**Soil-Gas  
Investigation Report**

**354 Area Solvent Detections  
(Operable Unit 005)**

**Main Post  
Fort Riley, Kansas**

**Subject: Soil-Gas Investigation Report  
354 Area Solvent Detections (Operable Unit 005)  
Main Post, Fort Riley, Kansas**

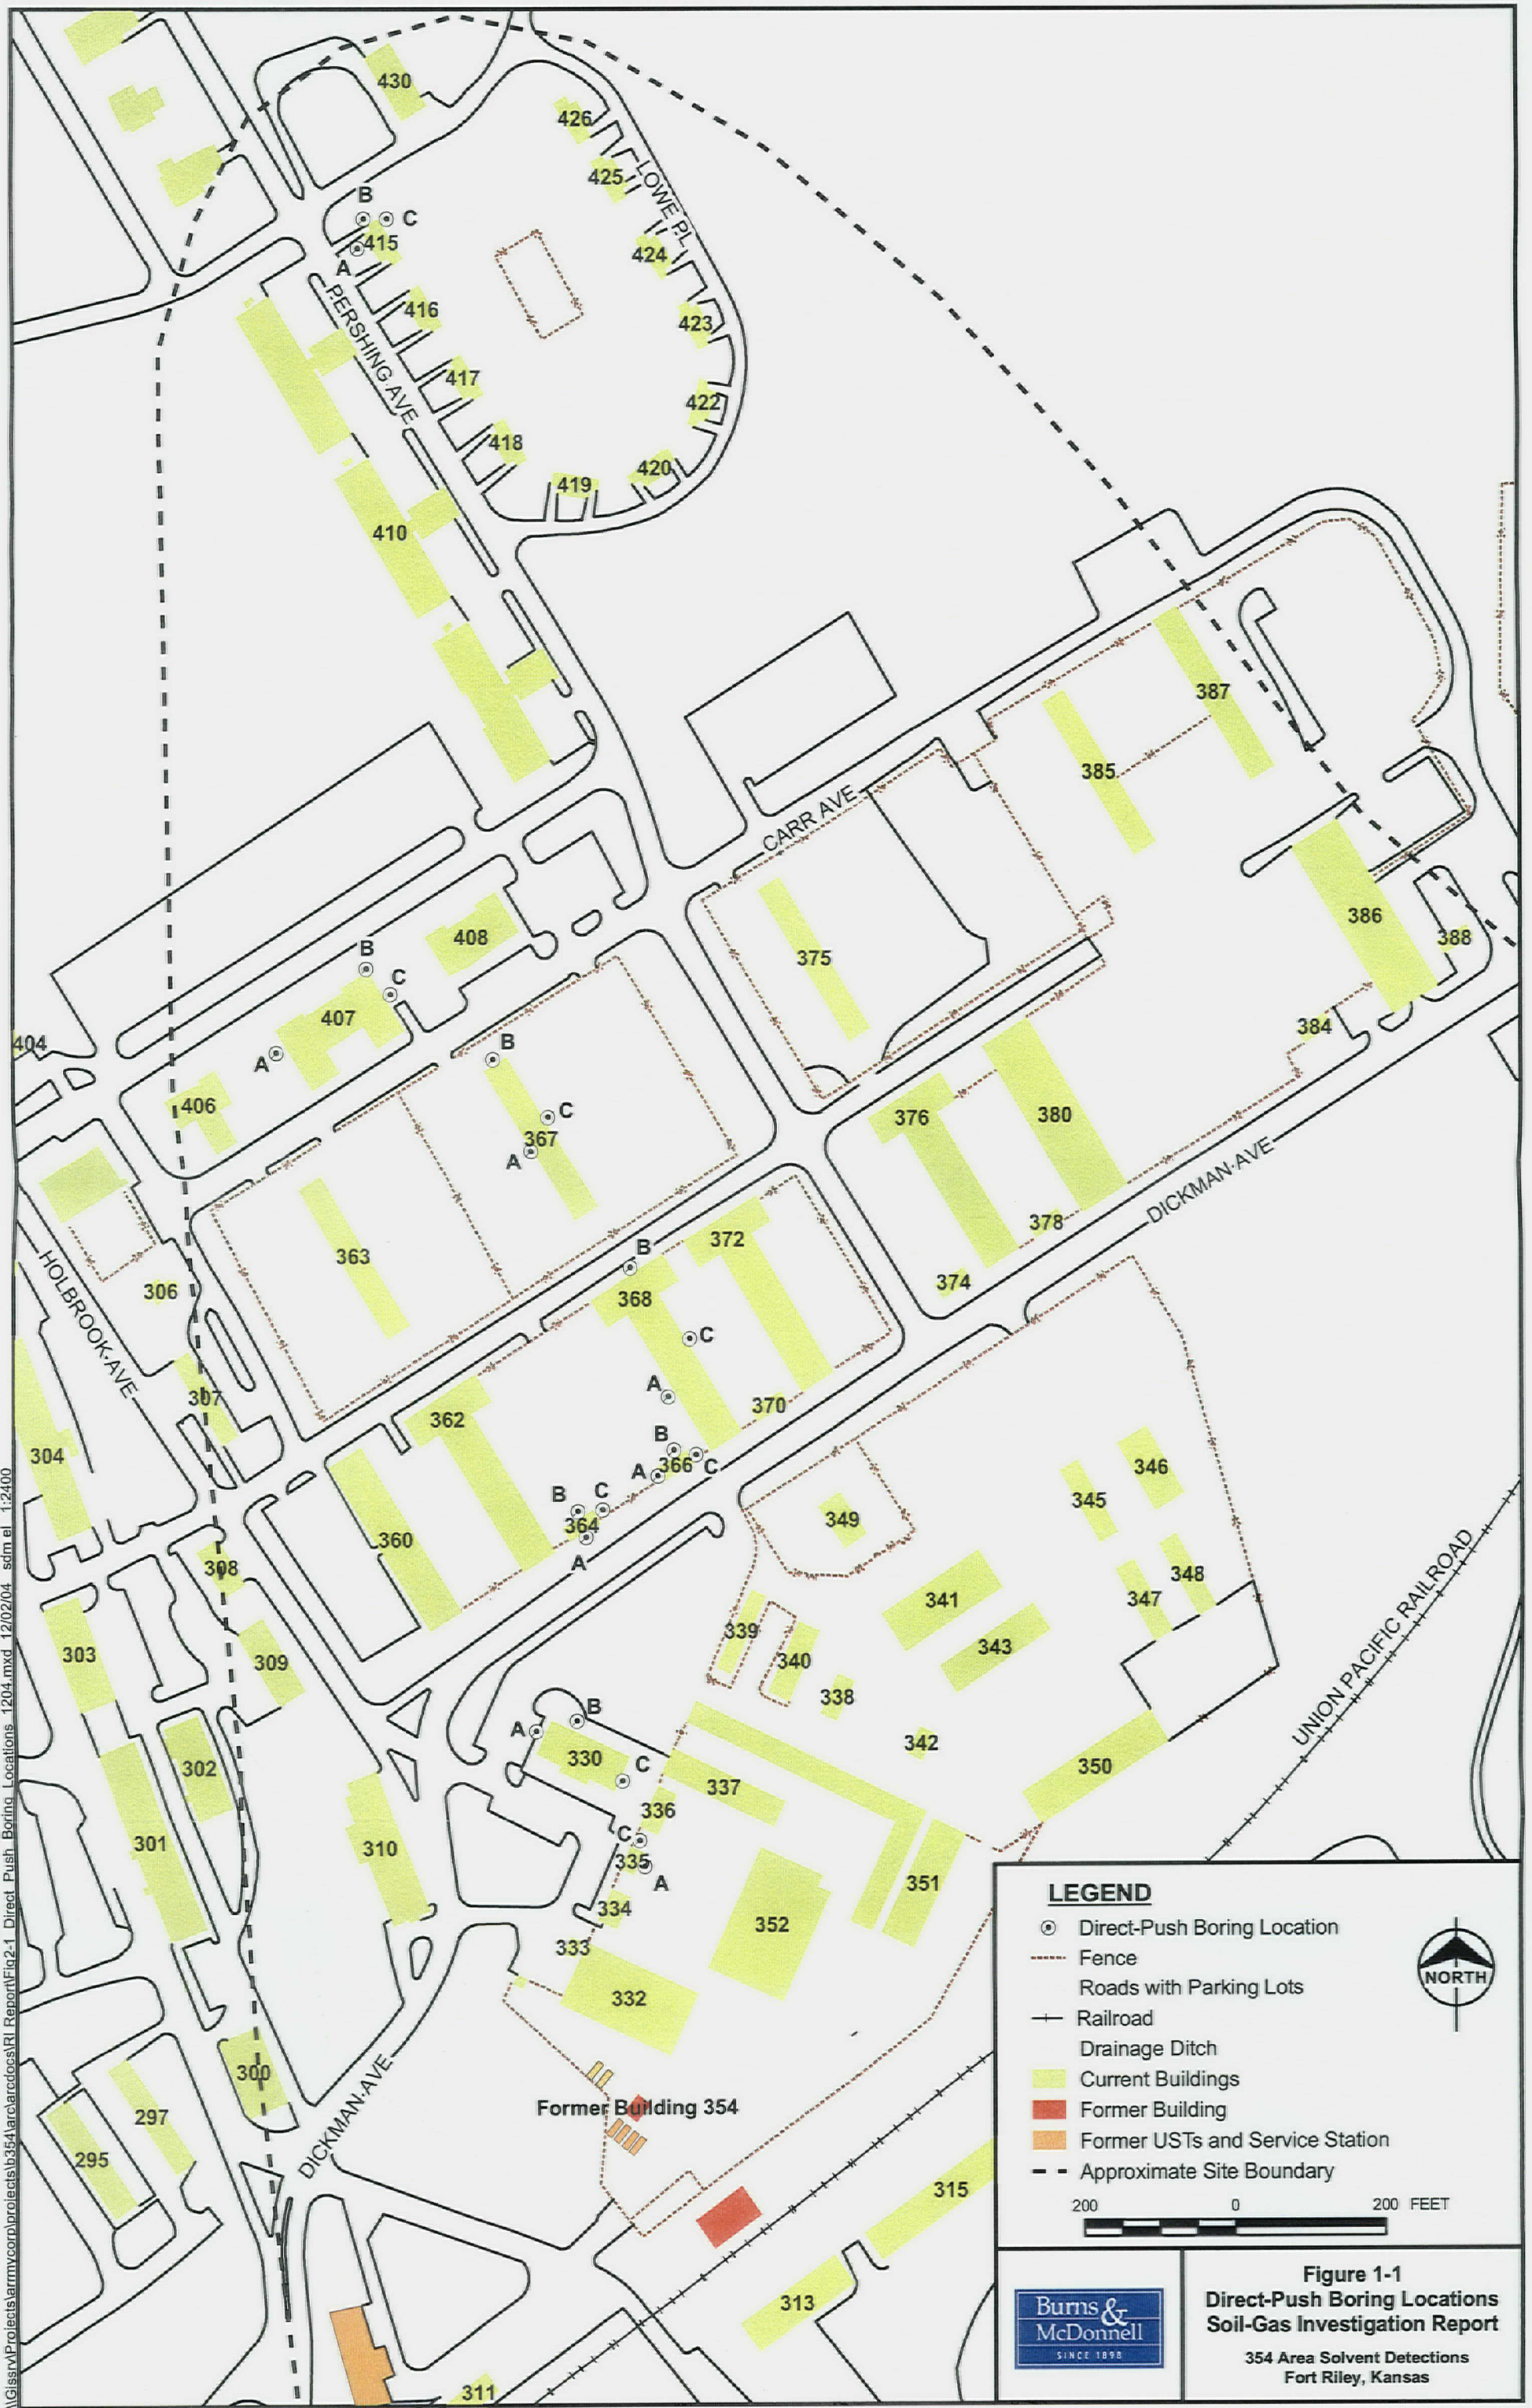
*This is incorrect!*
